**Flood Control Project Maintenance
Levee Inspections**
LMA District Cover Sheet
Spring 2014 Levee Inspection Results

Reclamation District No. 0501 Ryer Island

Levee Inspection Report By Mile - Spring 2014

Waterway	Bank	Unit Miles	Inspection Start/End	Inspector
Unit No. 01 Steamboat Slough	Right	6.76	04/02/2014 04/02/2014	Herman Phillips

Photo 1 of 1 : USACE2013A_STM_15-7_R_5.jpg

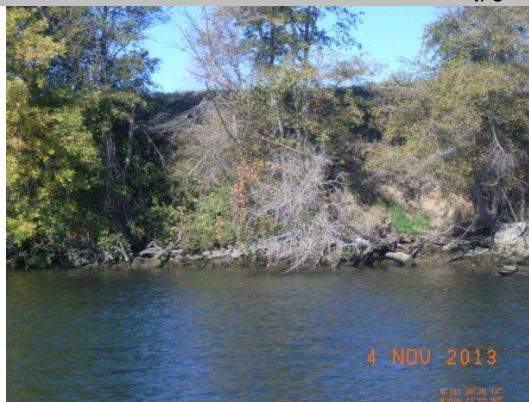
LM Start	5.75	Rating **	M	Issue No.	3
LM End	5.75	Issue Type +	Ma	Location *	WS
Category	Supplemental			GPS Latitude/Longitude	
				Start	End
Item	USACE Erosion Survey			38.189311 °	38.190001 °
				-121.643917 °	-121.643160 °
DWR ID					
Action/Comments					
Inspector Comments: 2008 - Overstepped levee section with multiple small pockets of erosion 10 - 20 ft wide. 2013: Site has fresh erosion and taller vertical sections. [2013 Site ID: STM_15-7_R]

Photo 1 of 1 : UCIP_2050.jpg

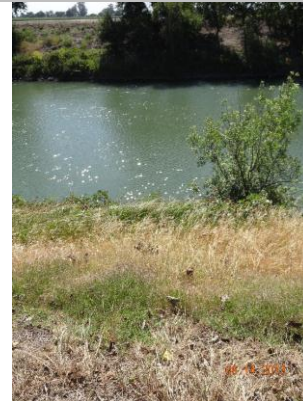
LM Start	1.11	Rating **	M	Issue No.	12
LM End	1.11	Issue Type +	En	Location *	LS
Category	Supplemental			GPS Latitude/Longitude	
				Start	End
Item	DWR UCIP Field Study			38.271400 °	38.271400 °
				-121.604368 °	-121.604368 °
DWR ID	DWR_RD0501_04_s_2014_12				
Action/Comments					
Inspector Comments: FS_ID:19675					
EP_NO: N/A					
Repair Type:					
Crossing Status:					
UCIP Comments: Unable to determine if the pipe goes through the					
levee; is this an authorized encroachment?--need As-Built drawings;					
Need owner information.					
FIELD_STRUCT_DESC: 1.5-inch conduit through the levee, 2.0 feet					
below the crown. Pole and anchor on landward slope.					
FS Date: 6/13/2013

Photo 1 of 1 : UCIP_2055.jpg

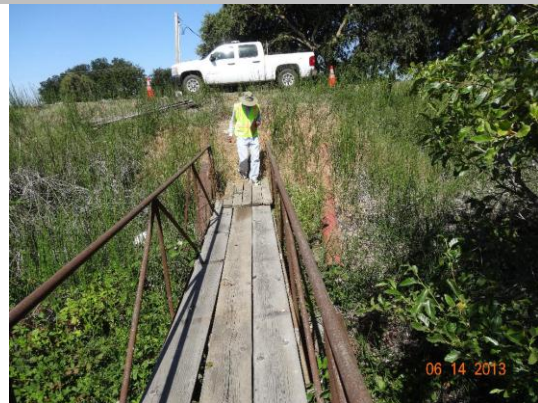
LM Start	1.20	Rating **	M	Issue No.	15
LM End	1.20	Issue Type +	En	Location *	LS
Category	Supplemental			GPS Latitude/Longitude	
				Start	End
Item	DWR UCIP Field Study			38.270171 °	38.270171 °
				-121.604403 °	-121.604403 °
DWR ID	DWR_RD0501_04_s_2014_15				
Action/Comments					
Inspector Comments: FS_ID:19676					
EP_NO: N/A					
Repair Type:					
Crossing Status:					
UCIP Comments: Abandoned pipe visible on waterward side--could be the pipe that was supposed to be removed under permit number 13983 (1985). Also present is an abandoned 1.5 inch conduit along the 8 inch pipe. Need to coordinate with owner.					
FIELD_STRUCT_DESC: 8-inch steel pipe through the levee, 6.4 feet below the crown. Pump on pile structure in stream. Service pole on landward slope. (USACE-1959). This entry matches the Drainage or Irrigation Structure referenced in O&M manual (HLM 1.30). Pipe should have been removed and replaced with 12-inch pipe under Permit No. 13983 (1985).

Photo 1 of 1 : UCIP_2065.jpg

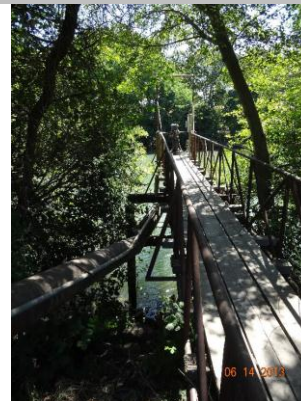
LM Start	1.90	Rating **	M	Issue No.	20
LM End	1.90	Issue Type +	En	Location *	LS
Category	Supplemental			GPS Latitude/Longitude	
				Start	End
Item	DWR UCIP Field Study			38.260407 °	38.260407 °
				-121.601365 °	-121.601365 °
DWR ID	DWR_RD0501_04_s_2014_20				
Action/Comments					
Inspector Comments: FS_ID:19678					
EP_NO: N/A					
Repair Type:					
Crossing Status:					
UCIP Comments: Unable to verify if comment from historical levee log (1980) indicating pipe was leaking is true. Dense vegetation limits the inspector's visibility to identify signs of pipe failure (leaks) along the waterward and landward slope. Recommend removing vegetation along pipe alignment to conduct proper inspection of structure and appurtenances.					
FIELD_STRUCT_DESC: 14-inch steel pipe through the levee, 8.0 feet below the crown. 2 inch conduit goes through levee. Siphon breaker on landward slope. Pump on pile structure in stream. (USACE-1959). This entry matches the Drainage or Irrigation Structure referenced in O&M manual (HLM 2.0).
